SUBJECT: O'FALLON COMMUNITY PARK ENHANCEMENTS
NEW POOL AND AMPHITHEATER (PHASE 1)
411 EAST 5TH STREET
O'FALLON, IL 62269

FGM Project No.: 23-3773.01

This Addendum forms a part of the Bidding and Contract Documents and modifies the original bidding documents dated February 14, 2024, and project Addendum #1 documents dated February 26, 2024. Acknowledge receipt of this Addendum in space provided on Bid Form. **Failure to acknowledge addenda may subject bidders to disqualification.**

ROOF FRAMING AREA B-C
SHEET NO.
S1.4
JOB NO. 23-3773.01
© 2023 FGM Architects Inc.

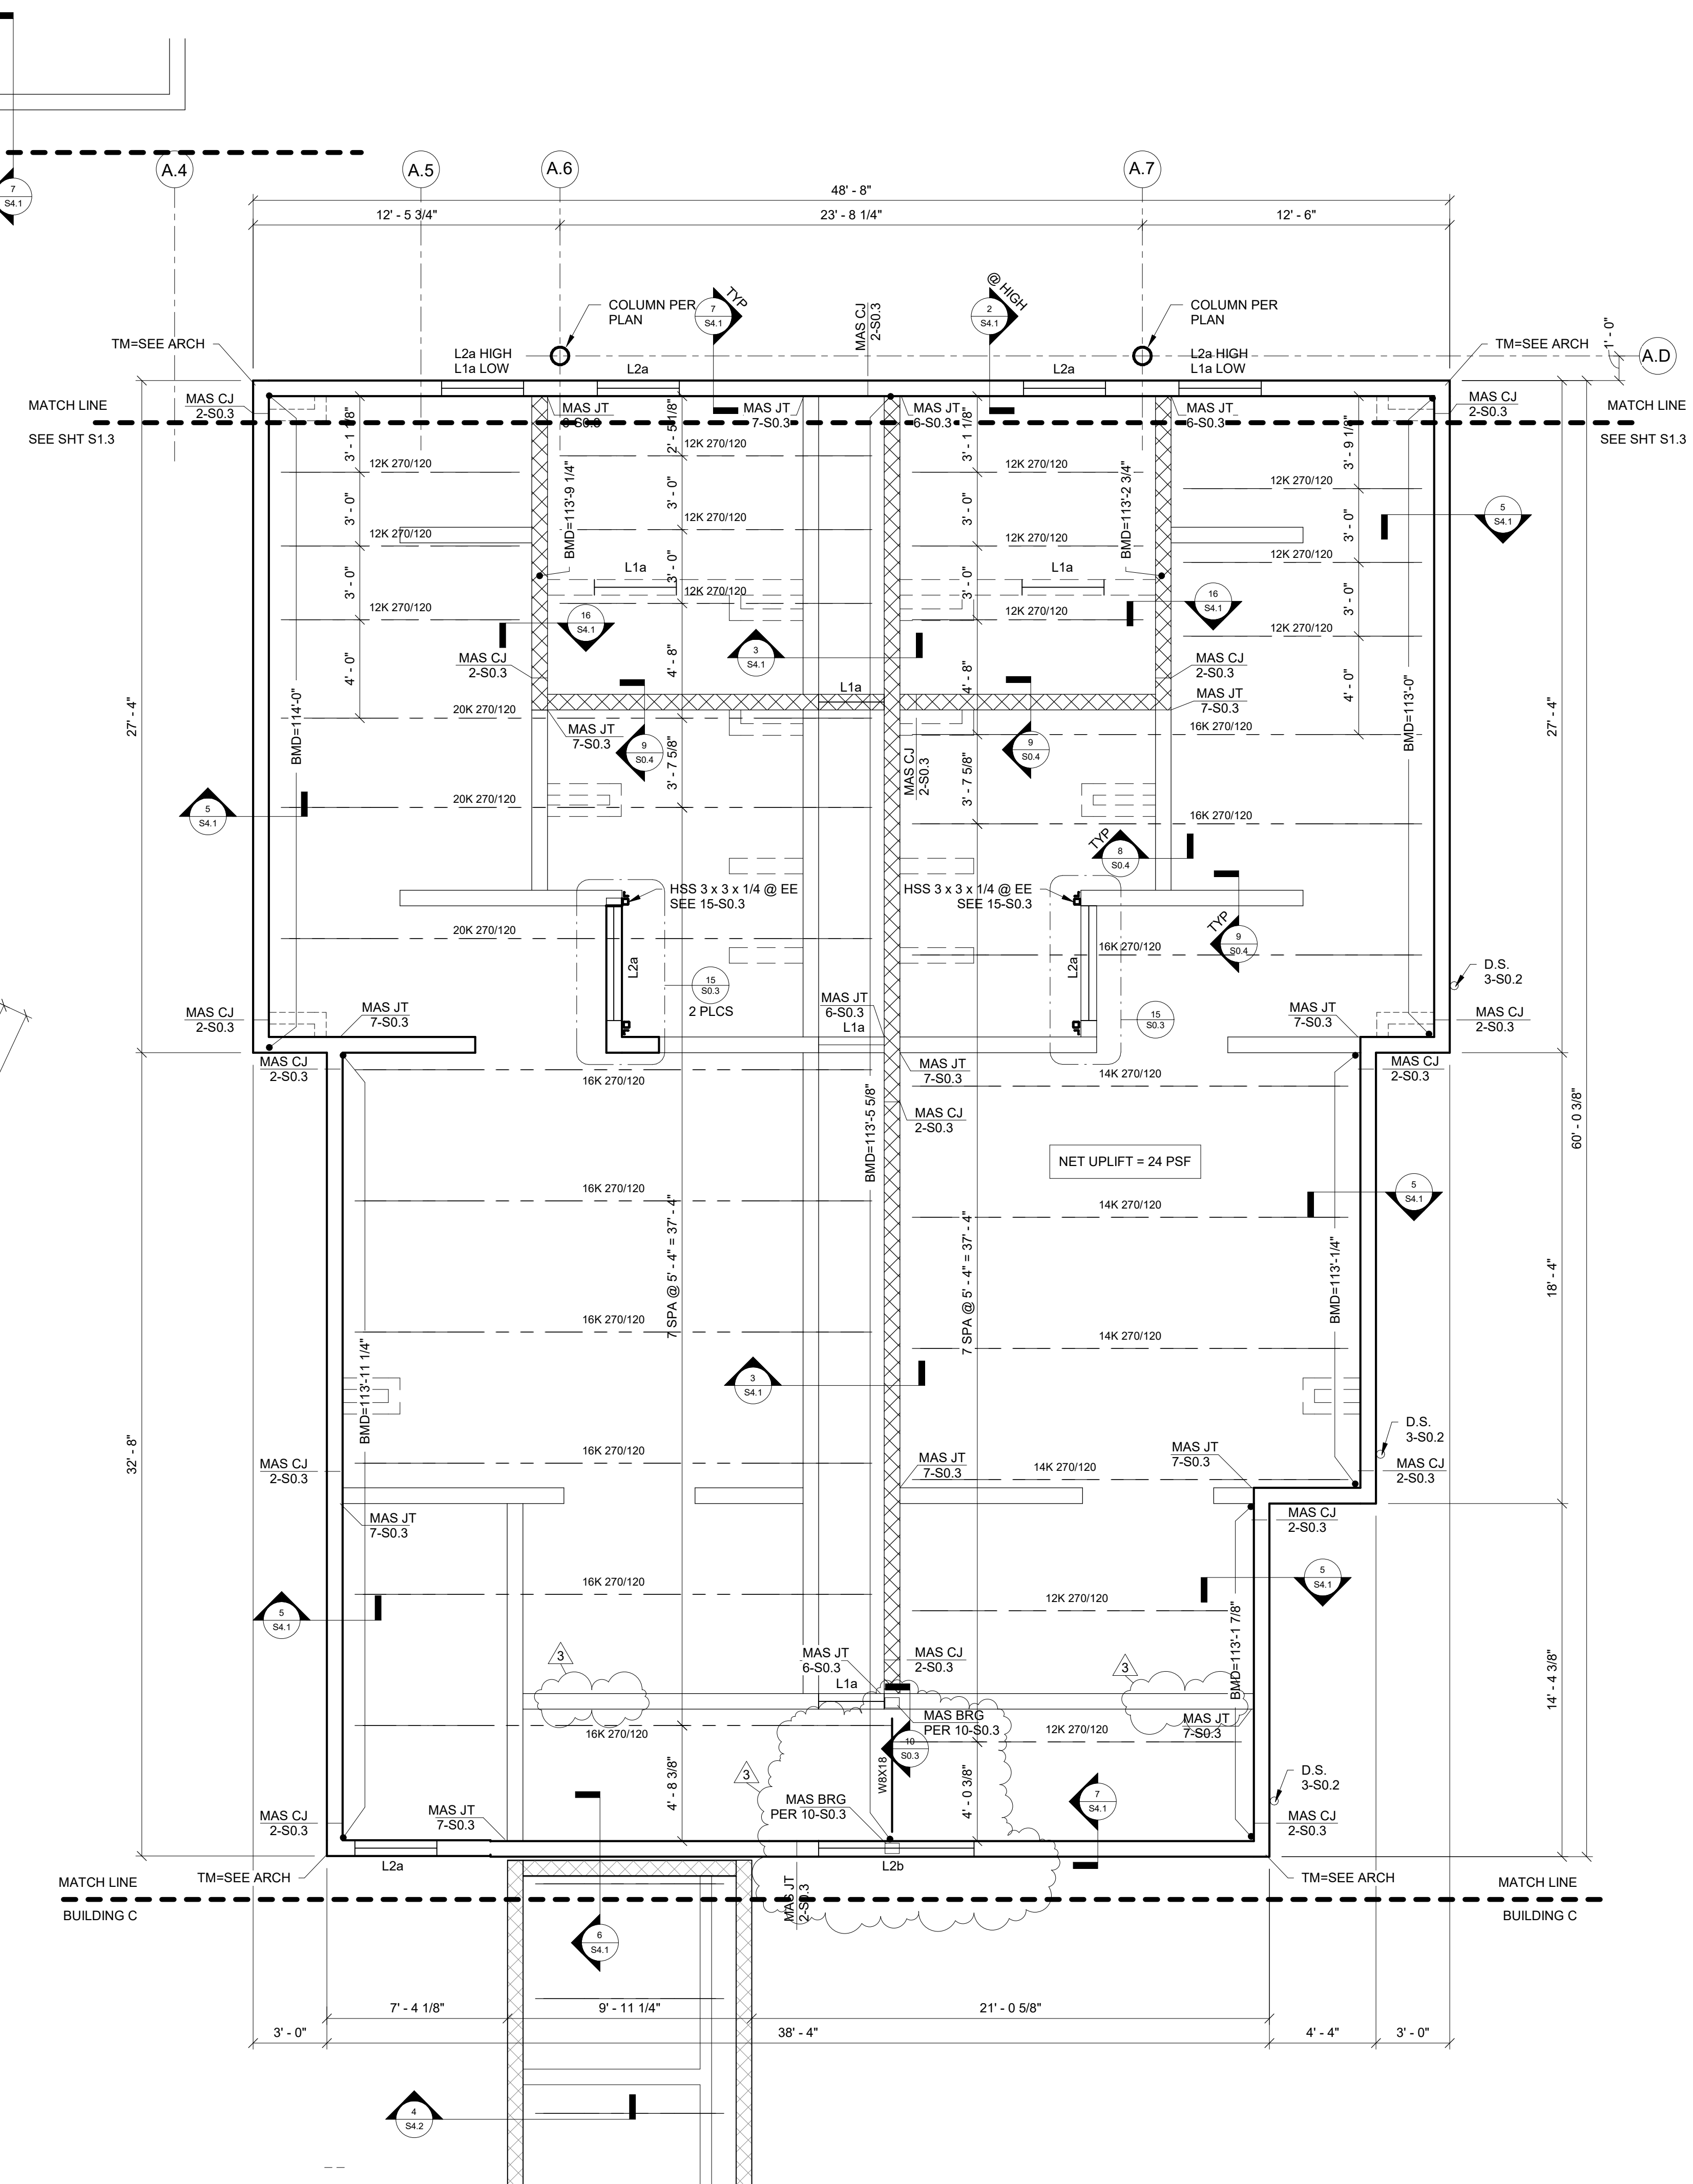
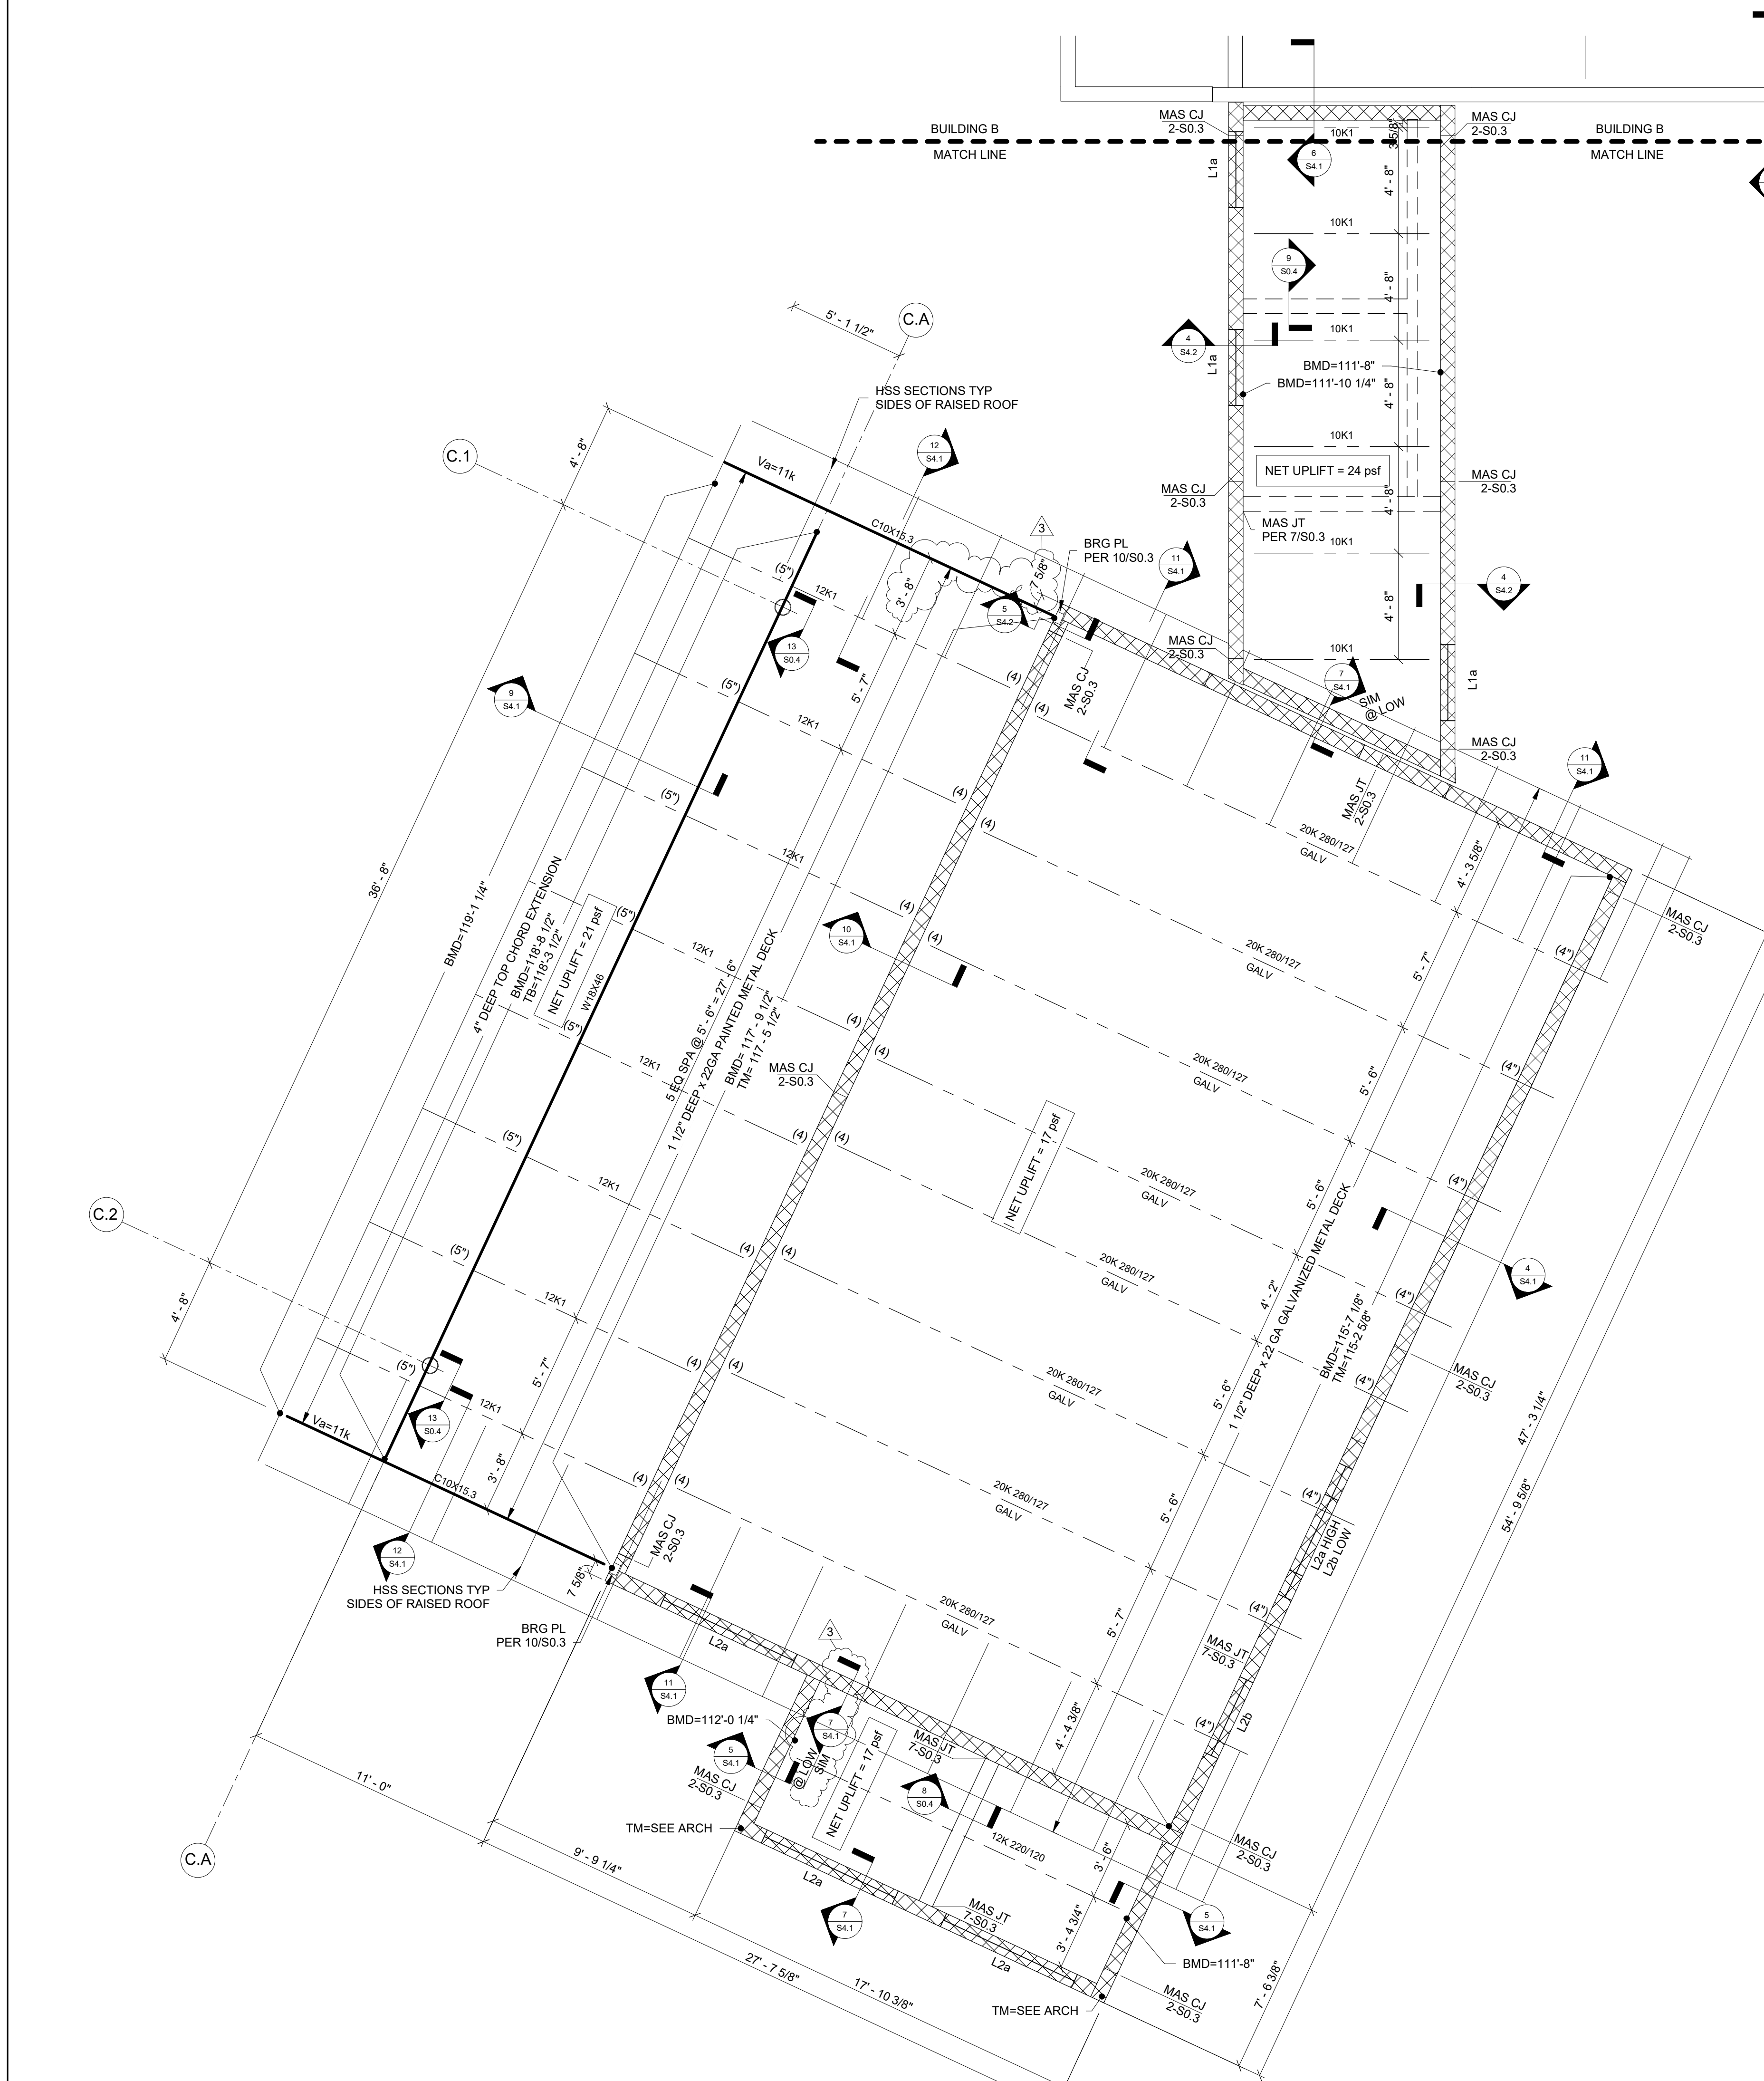
- A. **REVISE** dimension of C10x15.3 of the open canopy along at North wall from 3'-10" to **READ 3'-8"** and 5 5/8" to **READ 7 5/8"**.
- B. **ADD** Section Cut **7-S4.1 @ LOW/SIM** along the South wall at the low roof area.
- C. **REMOVE** Masonry opening and Masonry lintel between Rm. B134 and Rm. B135.
- D. **REMOVE** Masonry opening and Masonry lintel between Rm. B104 and Rm. B105.
- E. **REMOVE** Door opening masonry lintel @ Door B135 and Door B105.
- F. **REMOVE** Masonry lintel for louver above Door B135 and Door B105.
- G. **REMOVE** Masonry wall between Rm. B135 and Rm. B105.
- H. **ADD NEW** Masonry lintel '**L2b**' above new door opening for new 6'-0" door in South Wall of Bldg. B.
- I. **ADD NEW** Steel Beam **W8x18** and bearing plates at each end of beam above removed wall between Rm. B135 and Rm. B105.

FOUNDATION DETAILS AND SECTIONS
 SHEET NO. **S2.0**
 JOB NO. 23-3773.01
 © 2023 FGM Architects Inc.

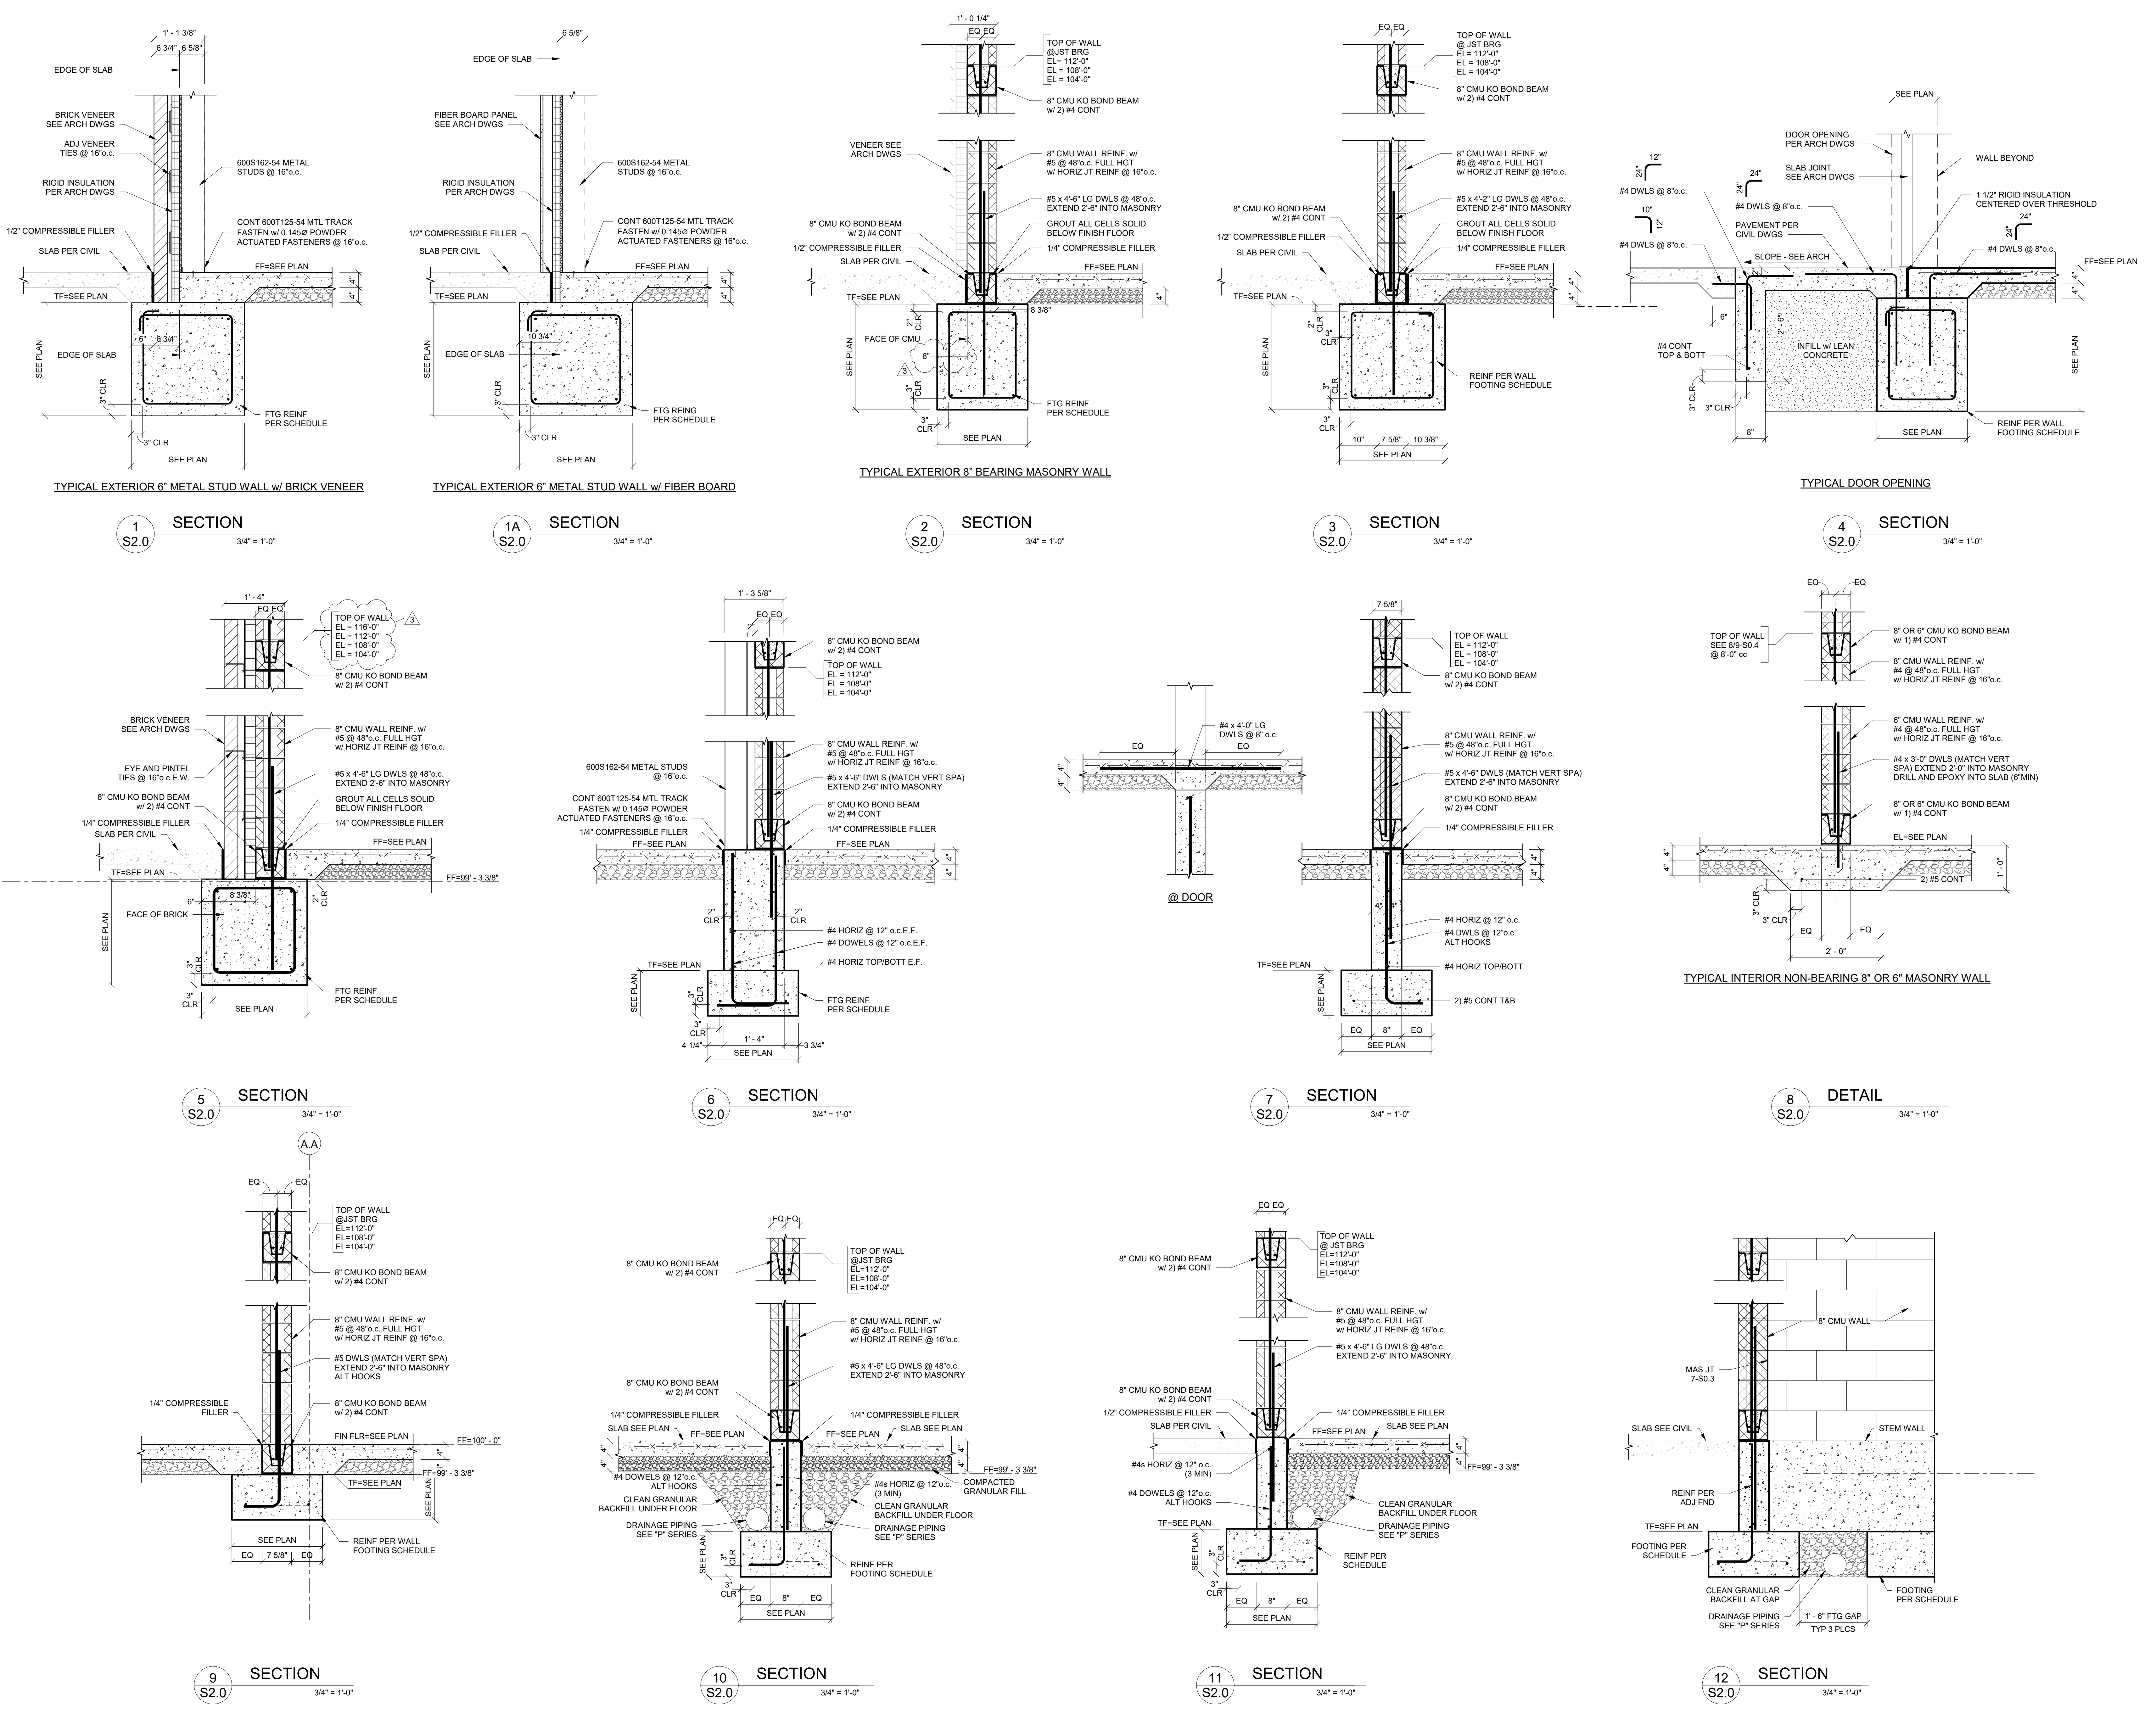
- A. **REVISE** Detail **2-S2.0** - **ADD** dimension **8"** from outside edge of Foundation to outside face of CMU Bond Beam.
- B. **REVISE** Detail **2-S2.0** – **ADD** an additional bond beam elevation **EL=116'-0"**
